University of South Carolina
Softball Stadium Construction
Columbia, SC

State Project No. H27-6088-MJ
Architect's Project No. 11.122.00
Addendum No. 2

April 24, 2012

ADDENDUM NO.2

SK-A-01

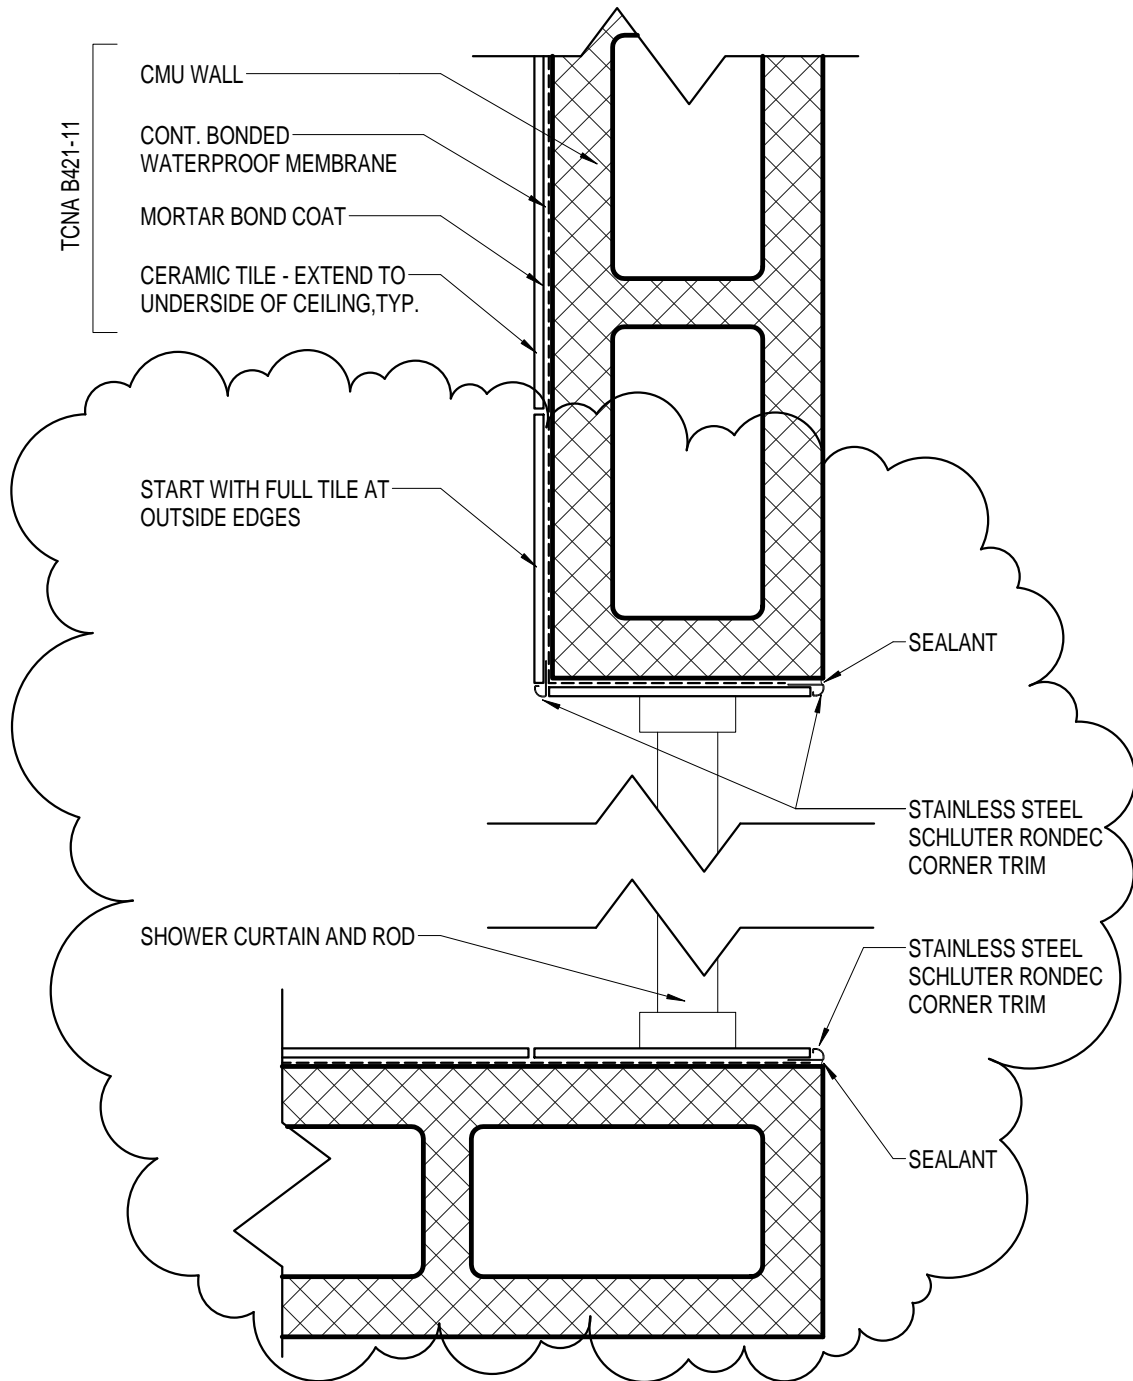
- c. Revise Door 108A Hardware to be Set 8.3
7. Reference A8.0 FINISH SCHEDULE, FINISH MATERIALS, DETAILS:
 - a. Replace detail 4/A8.0 with attached sketch SK-A-01

SK-A-02

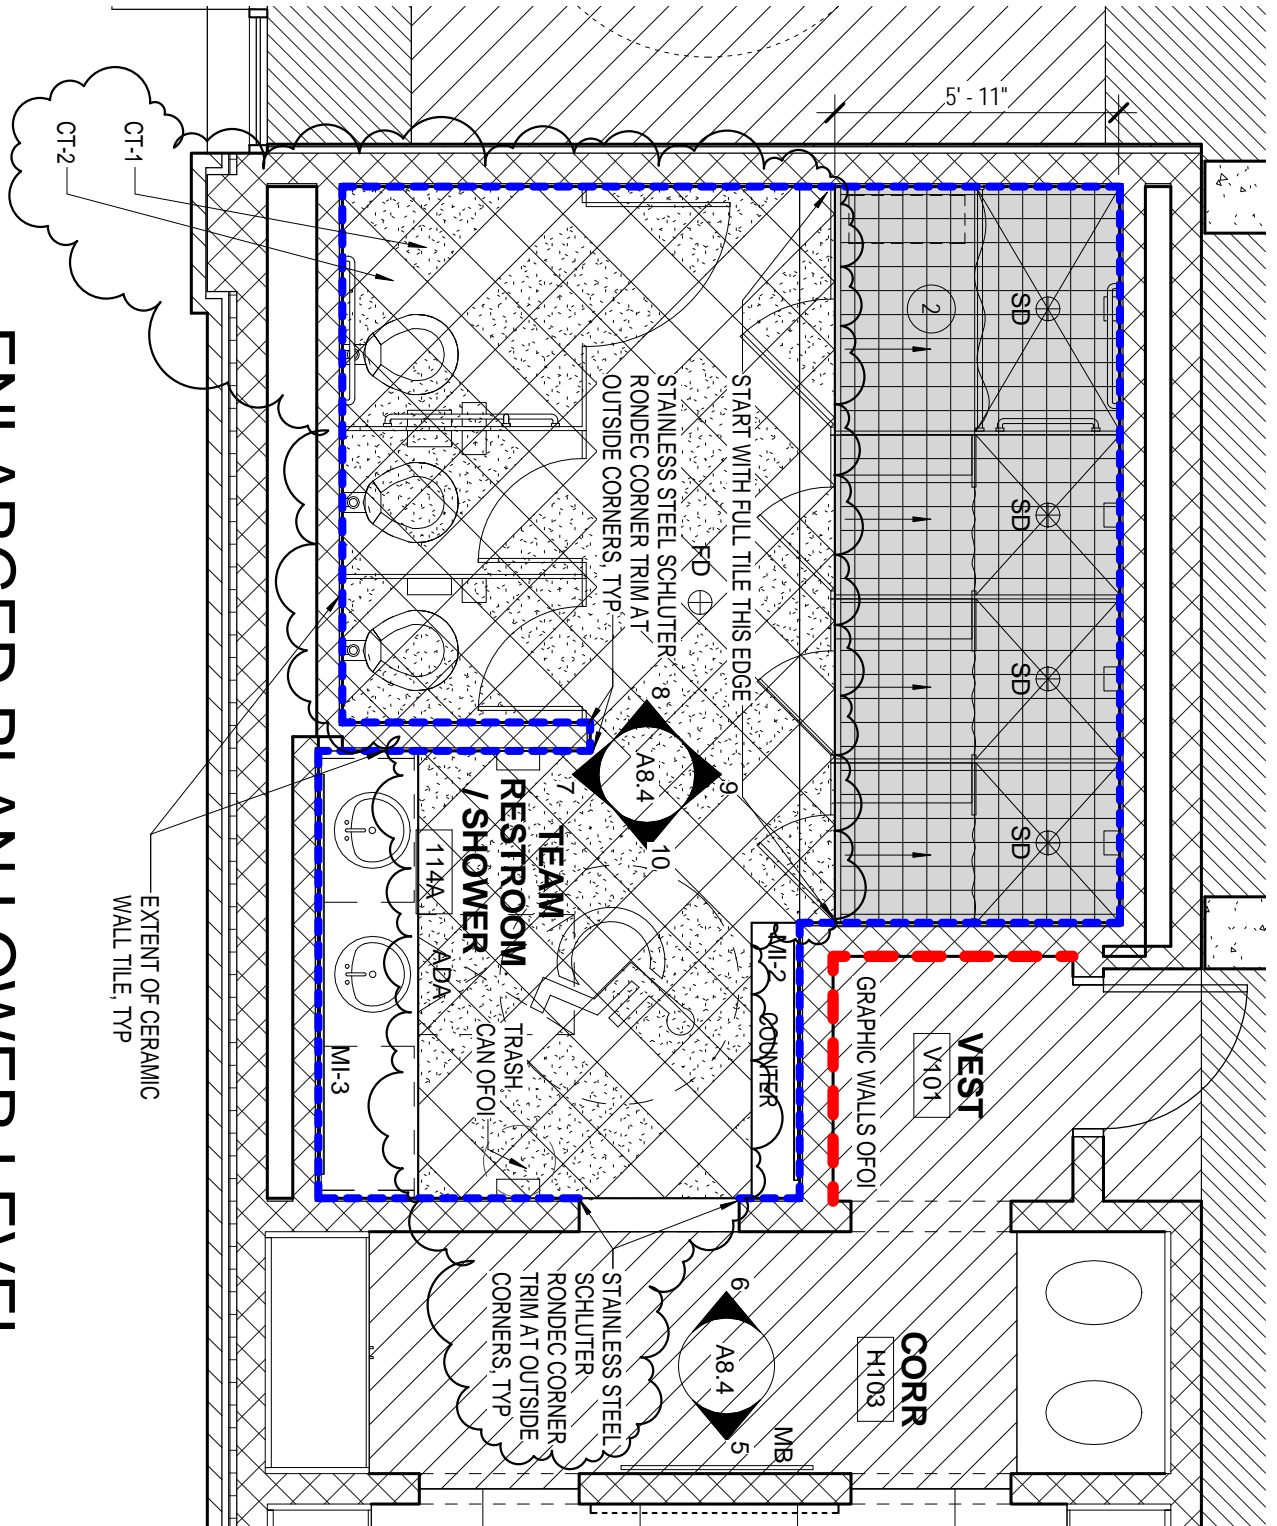
- b. See Sketch SK-A-02 for revised floor pattern at Team Restroom / Shower 114A. At Team Restroom/Shower 114A, provide stainless steel Schluter Rondec corner trim at the following locations: Outside corners at wall to wall transitions (3 locations); outside corners at masonry opening at entry to space (2 locations).

SK-S-01

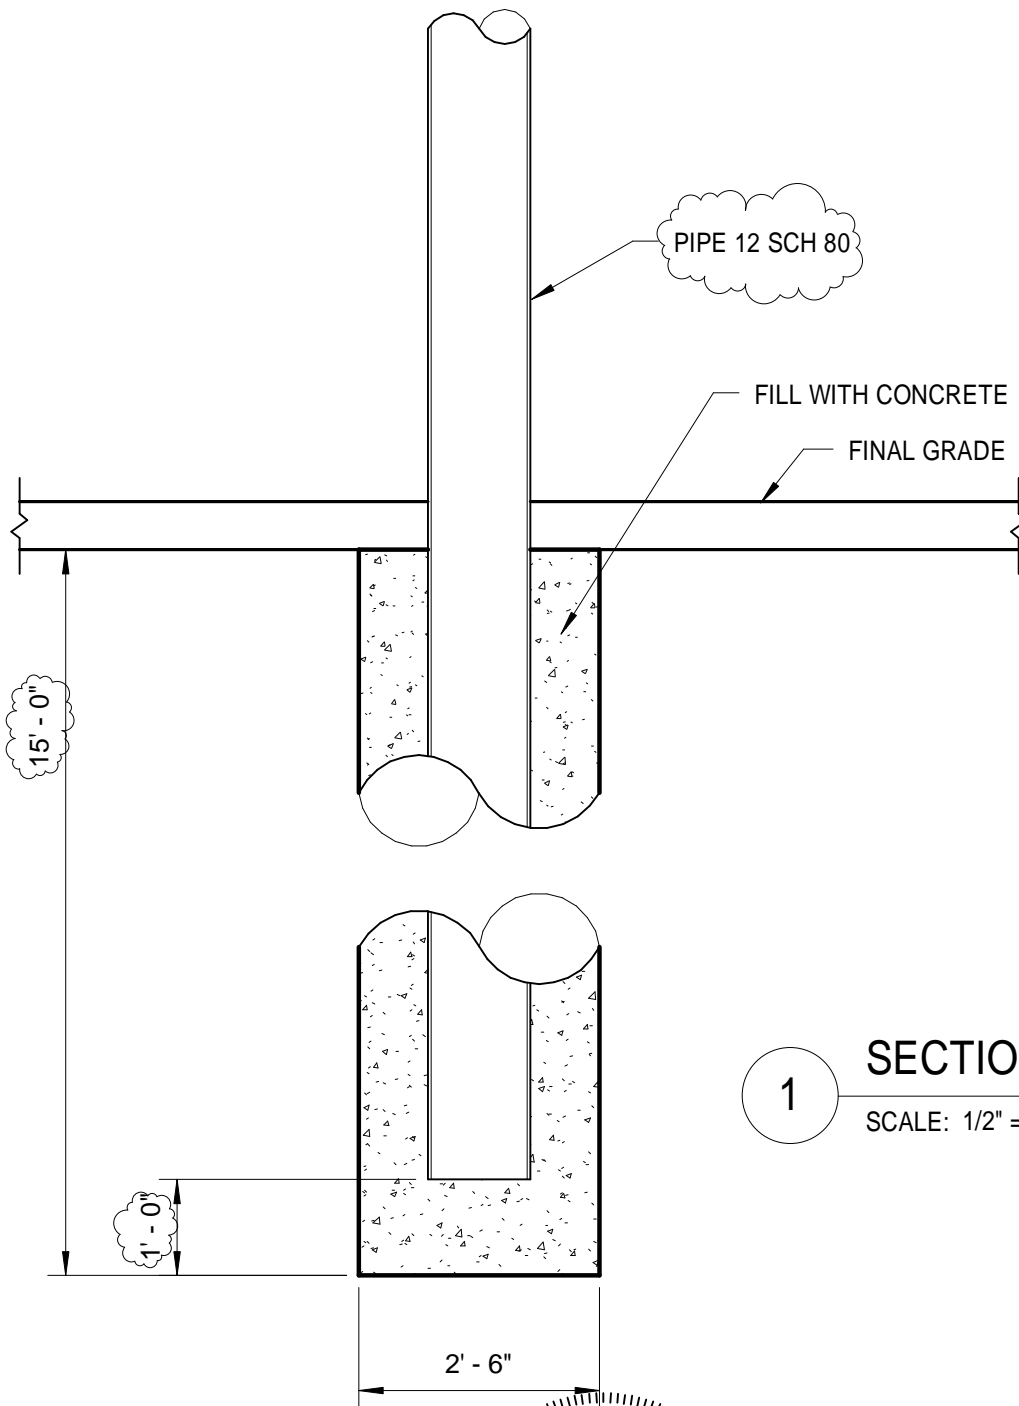
16. Reference drawing S5.3, Section 9:
Replace with attached Sketch SK-S-01

SK-S-02

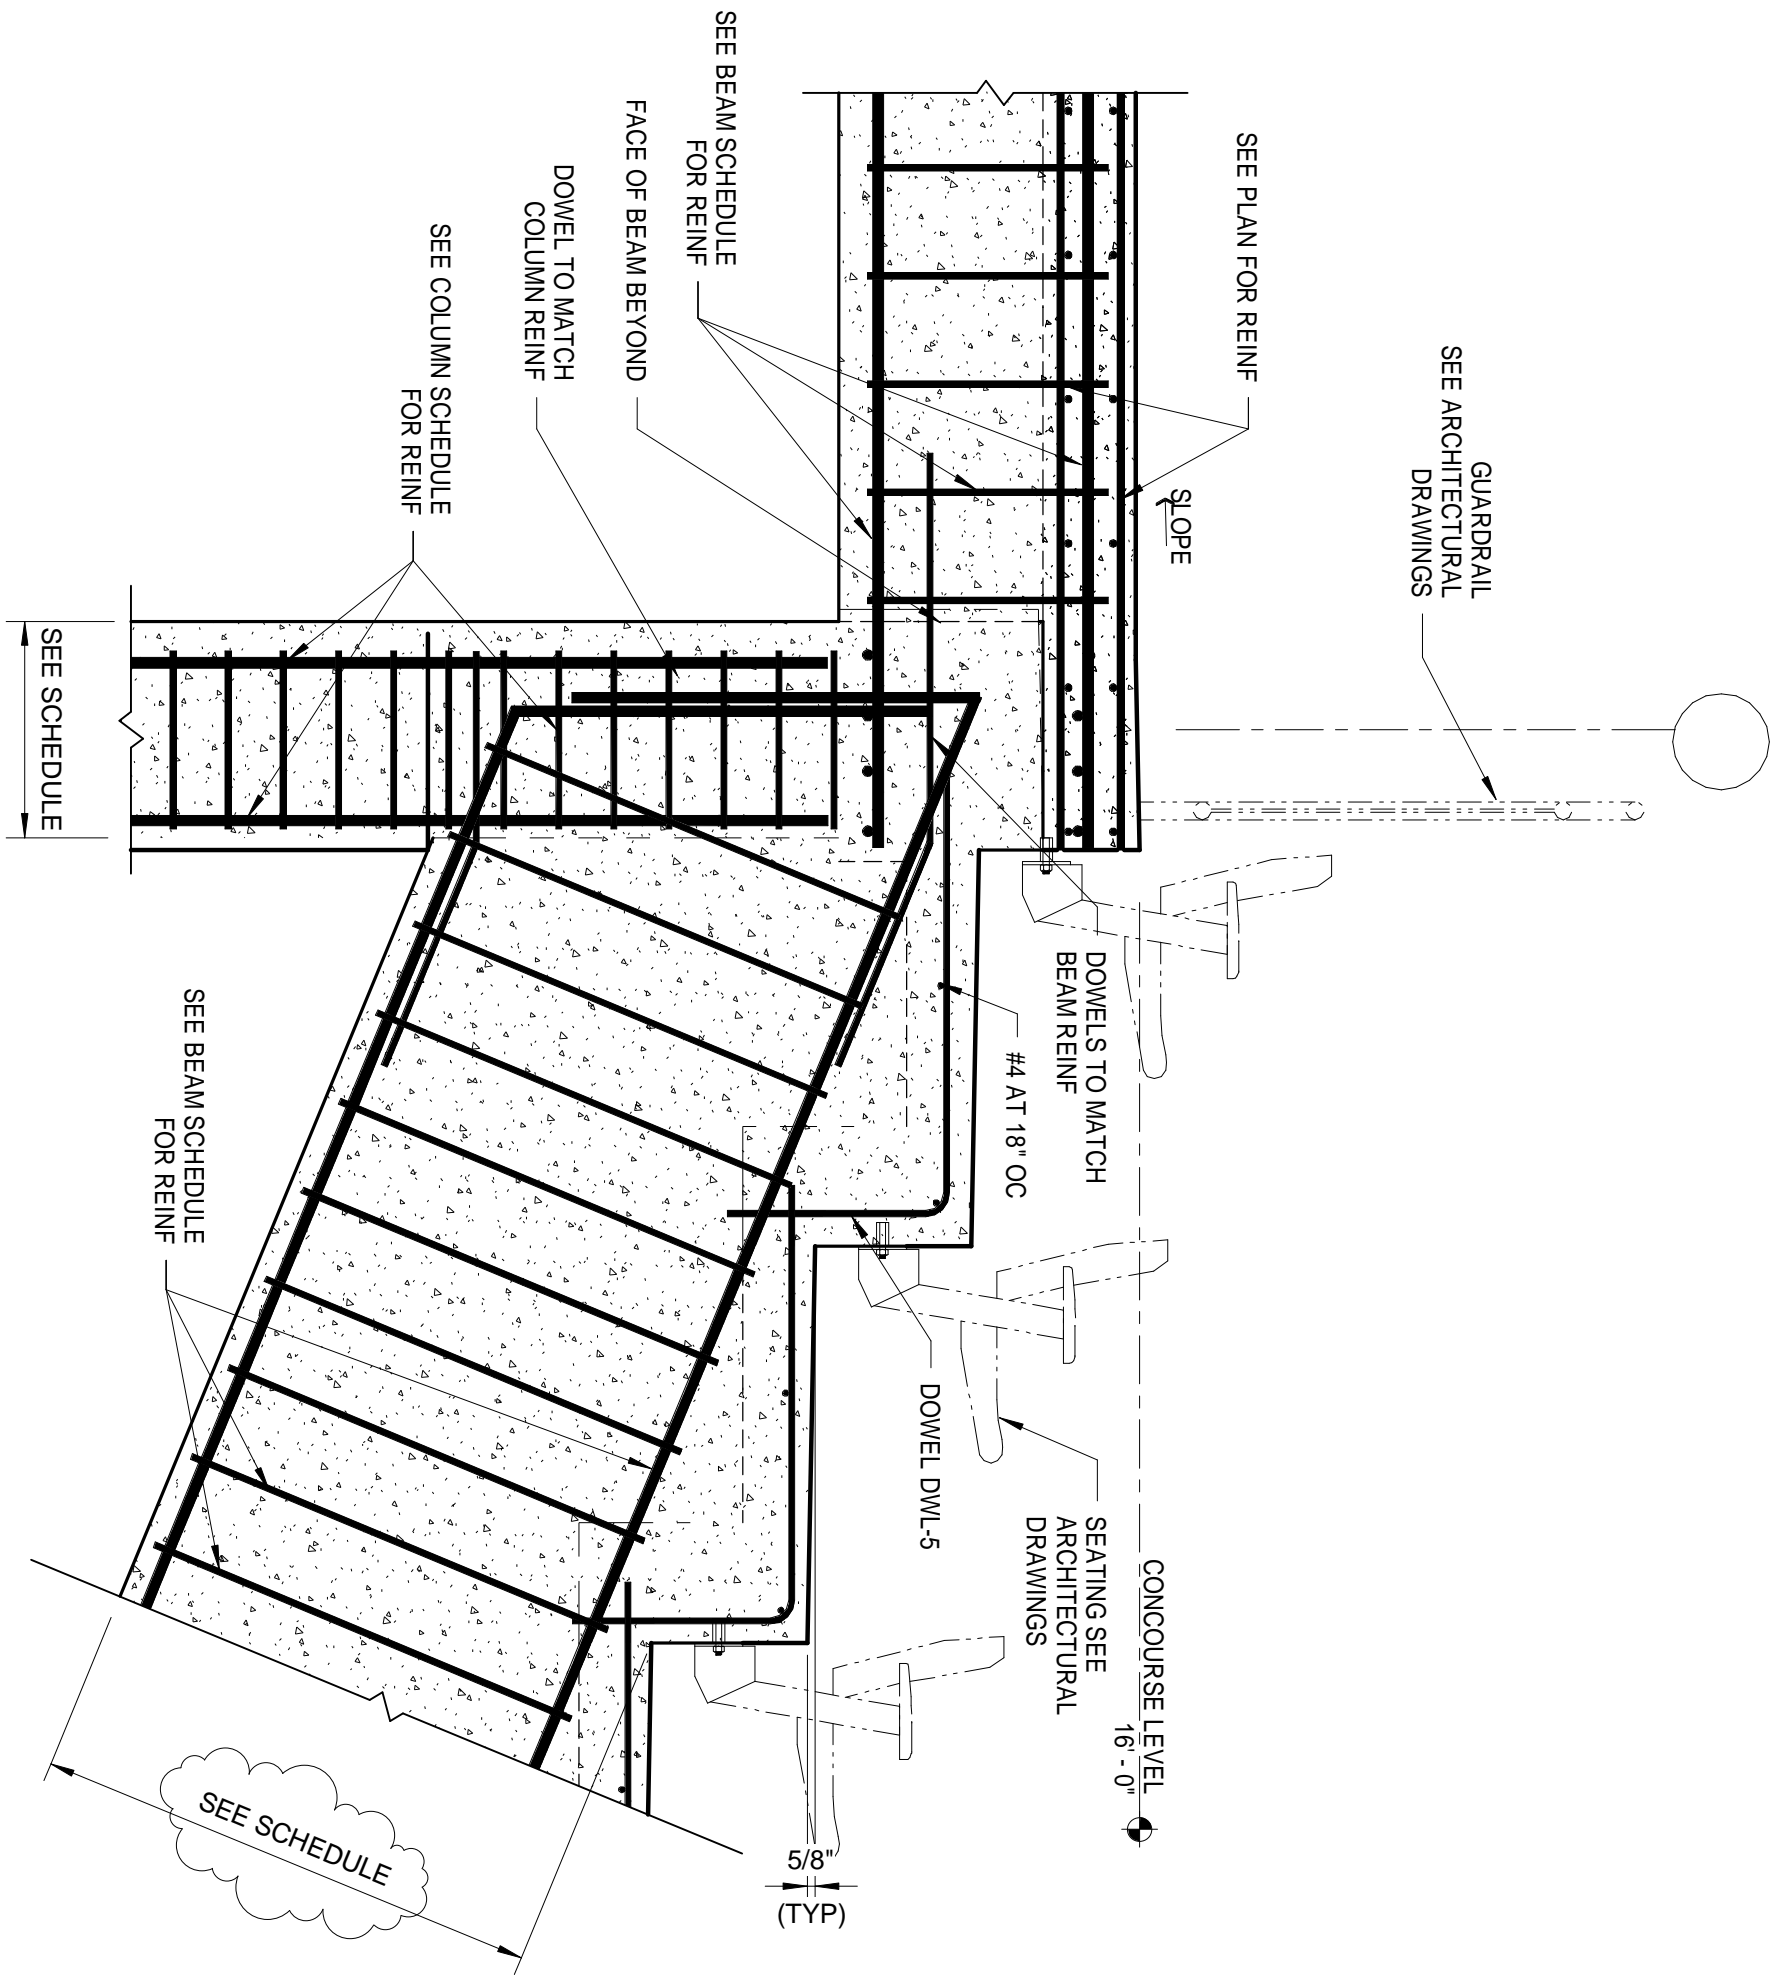
17. Reference drawing S6.1, UPPER FLOOR SECTIONS:
Replace Detail 5 with attached Sketch SK-S-02
Replace Detail 12 with attached Sketch SK-S-03

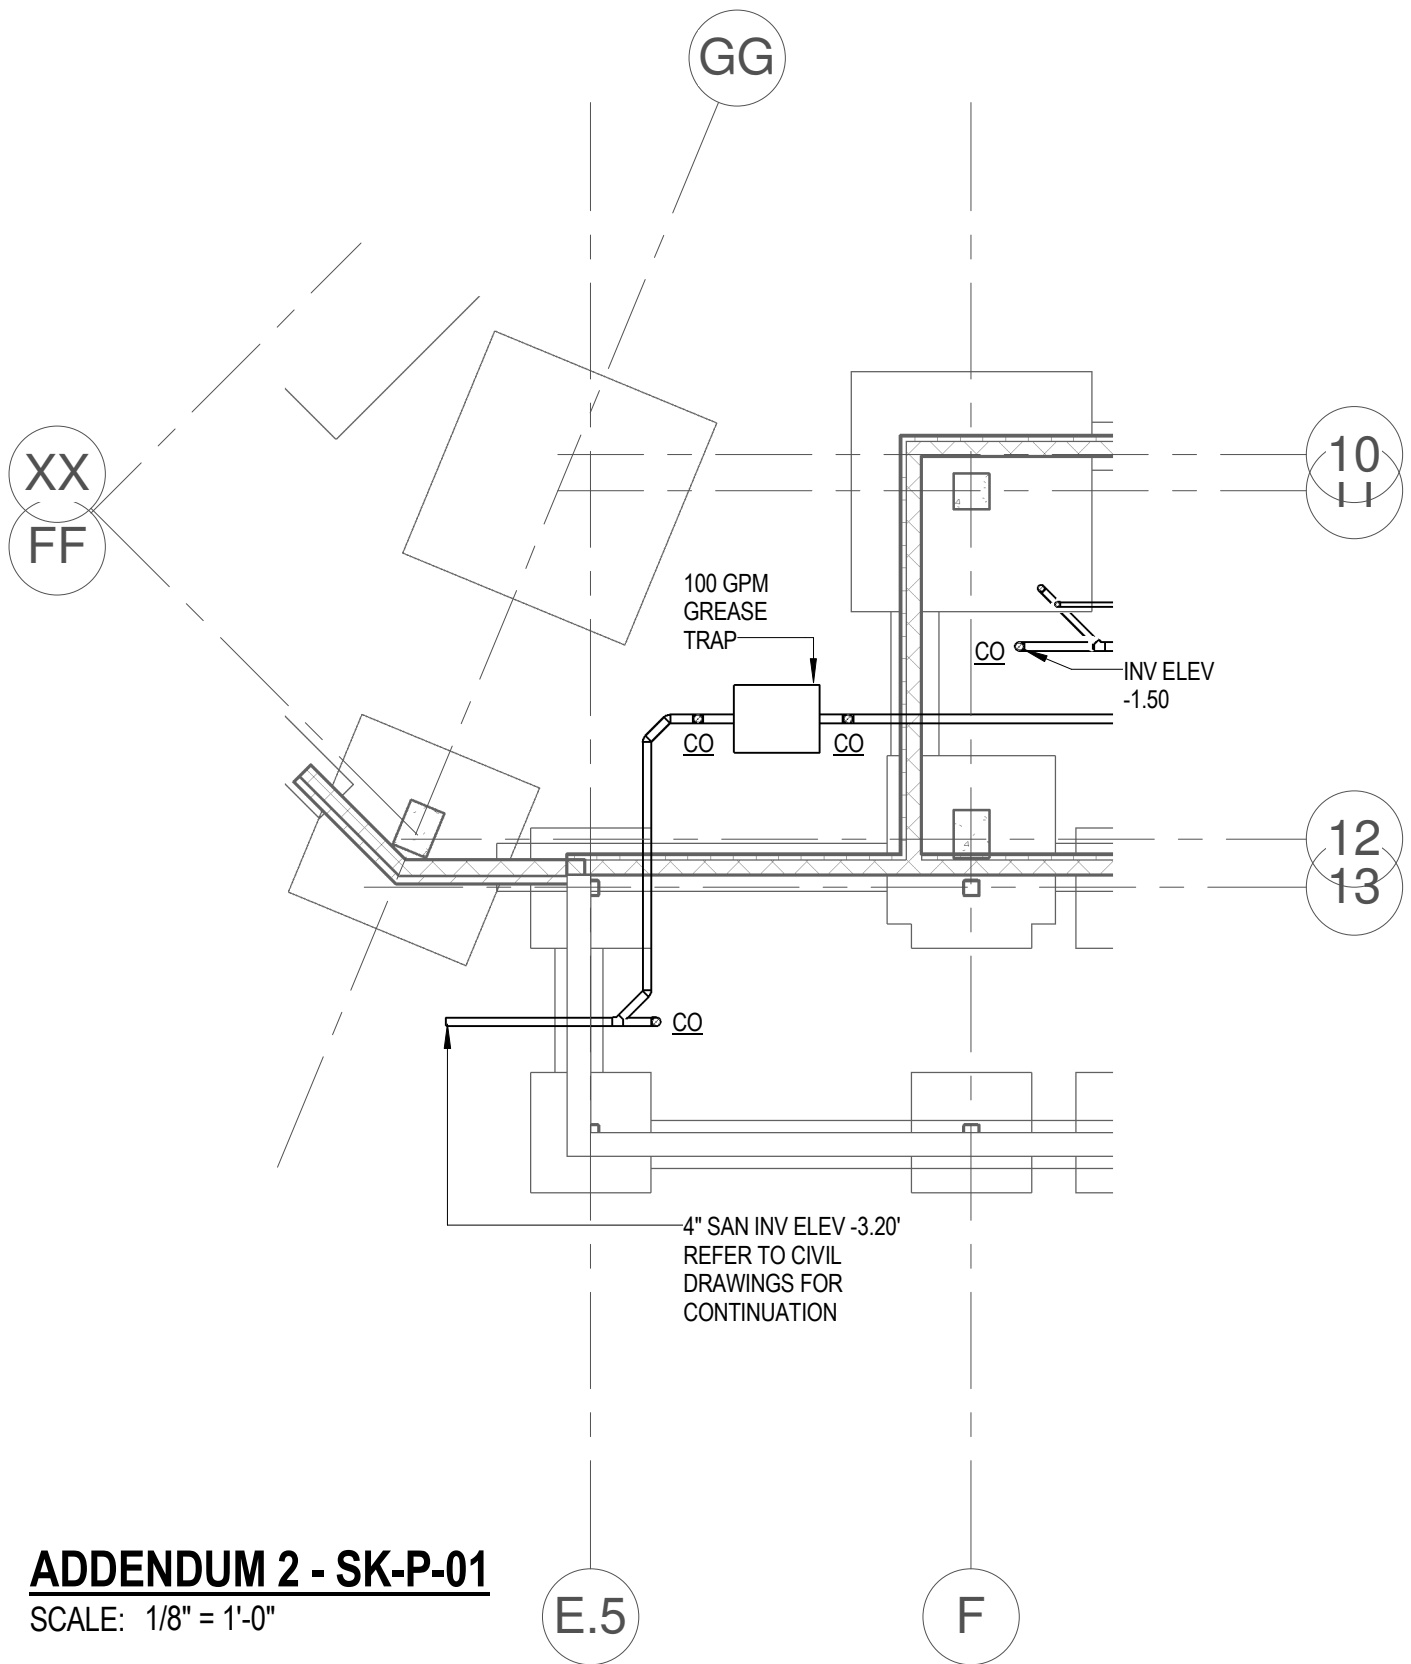
18. Reference drawing P100: 4" sanitary line from grease trap has been re-routed to exit the building as shown on sketch SK-P-01.
